Agency: U.S. Nuclear Regulatory Commission
Advisory Committee On Reactor Safeguards

Title: SUBCOMMITTEE MEETING ON ADVANCED
PRESSURIZED WATER REACTORS

DATE: Tuesday, April 3, 1990

- O ACRS SUBCOMMITTEE COMMENTS ON SYSTEM 80+
 LICENSING REVIEW BASIS DOCUMENT (LRB)**
- O REVIEW SYSTEM 80+ DESIGN FEATURES**

SYSTEM 80 REACTOR VESSEL COMPARISON

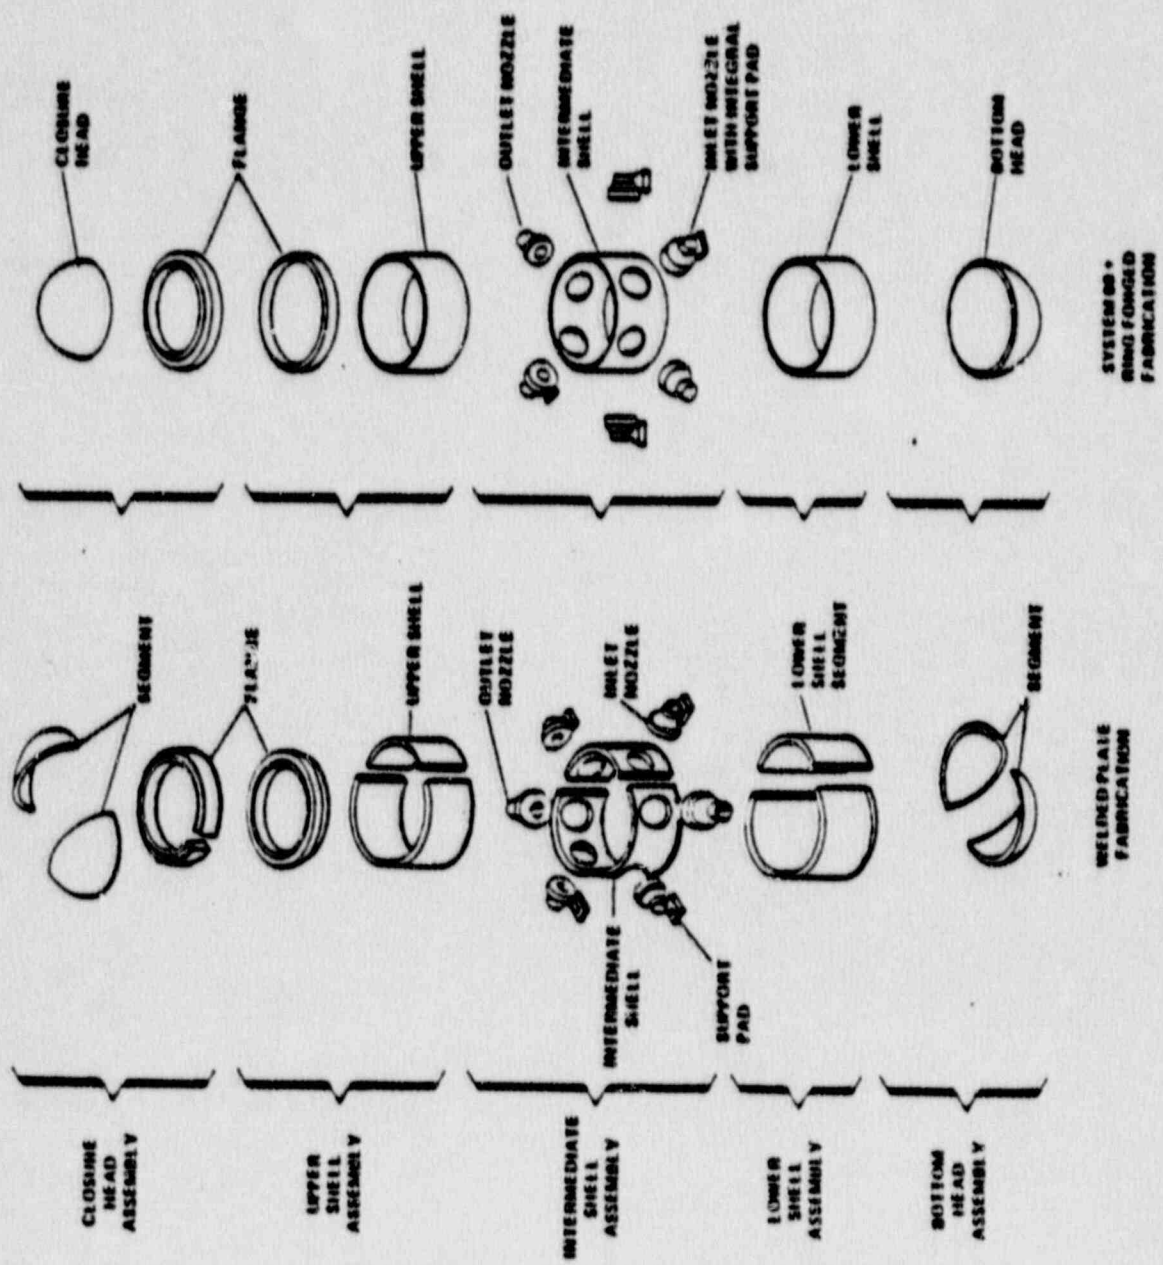
22 MR. MICHELSON: One question yet. On the vessel,
23 was this a Palo Verde vessel?

5 MR. MICHELSON: And does CE think that sort of
6 action is not necessary for future plants?

24 MR. MICHELSON: Higher than shown on this drawing?

13 MR. CATTON: But now they've reduced the
14 temperature which increases the density a little bit.
15 They've increased the velocity a little bit, and all these
16 things kind of lead in the wrong direction. What makes you
17 believe that with this change, you're still all right?

8 MR. TURK: We made a significant change in our
9 Palo Verde vessel. Our Palo Verde vessel is significantly
10 different than the previous vessels for instance at San
11 Onofre, Waterford, St. Lucie, okay? To some degree we think
12 that Westinghouse was playing a little bit of catchup.

7 MR. TURK: No, exactly the same internals. I said
8 Palo Verde was a change from San Onofre and Waterford.
9 These are exactly the same, including the fixes that were
10 made to Palo Verde.

12 MR. TURK: The only change is the change to the
13 control alternate assembly design where we have kept the 48
14 B-4C full strength, 12-finger shutdown rods, however, have
15 taken the four finger control elements and reduced them in
16 number to 20 and changed the material to silver Indium
17 Cadmium to increase the lifetime, and then added 13 part
18 length rods, while deleting -- I'm sorry -- adding 25 part
19 strength rods, Inconel rods while deleting the 13 part
20 length four finger rods that were included in the original
21 System 80 design for a net increase of 4 control element
22 assemblies with now a 20 year lifetime versus the 10 year
23 lifetime.

3 MR. MATZIE: It really doesn't have any effect.
4 If you look at the design, with that center Calandria region
5 -- I don't know if you want to put it back up -- which was
6 the major design change for System 80 relative to previous
7 plans, there's an individual shroud for every control rod
8 finger location. We don't use all the locations on System
9 80. We're using a few more of those locations on System 80
10 Plus.

11 That section where he's pointing now, the
12 Calandria region, that's where the flow turns and goes out
13 of the nozzles. All those tubes are already there for not
14 only the additional rods we've added, but other rods that
15 in a future design actually could be added.
